UNITED STATES PATENT AND TRADEMARK OFFICE

APPLICATION NO.	FILING DATE	FIRST NAMED INVENTOR	ATTORNEY DOCKET NO.	CONFIRMATION NO.	
10/008,766	11/07/2001	Robert H. Mimlitch III	50097-00003PT	9188	
26231 7	590 05/06/2004		EXAMINER		
FISH & RICHARDSON P.C. 5000 BANK ONE CENTER 1717 MAIN STREET			FERGUSON, MICHAEL P		
			ART UNIT	PAPER NUMBER	
DALLAS, TX	DALLAS, TX 75201			3679	
			DATE MAIL ED. 05/06/200	4

Application No.	Applicant(s)				
	10/008,766	MIMLITCH ET AL.				
Office Action Summary	Examiner	Art Unit				
	Michael P. Ferguson	3679				
The MAILING DATE of this communication appeared for Reply	pears on the cover sheet with the c	orrespondence address				
A SHORTENED STATUTORY PERIOD FOR REPL THE MAILING DATE OF THIS COMMUNICATION. - Extensions of time may be available under the provisions of 37 CFR 1.1 after SIX (6) MONTHS from the mailing date of this communication. - If the period for reply specified above is less than thirty (30) days, a repilif NO period for reply is specified above, the maximum statutory period Failure to reply within the set or extended period for reply will, by statute Any reply received by the Office later than three months after the mailing earned paten

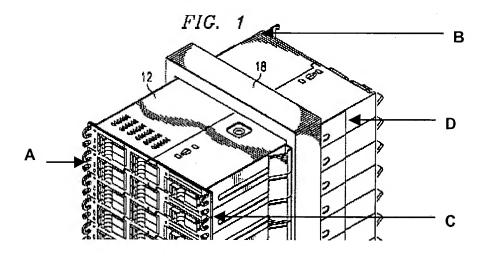
a fourth coupling member **20** coupled to and independently extending substantially horizontally outward from a second post, first, second, third and fourth coupling members each substantially replicating a different vertical upright **A,B,C,D** (Figure 1 reprinted with annotations below) in a four-post equipment rack (Figure 1).

wherein each of the coupling members emulate one respective post **A,B,C,D** in a four-post rack, with each emulate post defining a supporting point for a load (via the hole in flange **30**; Figure 1).
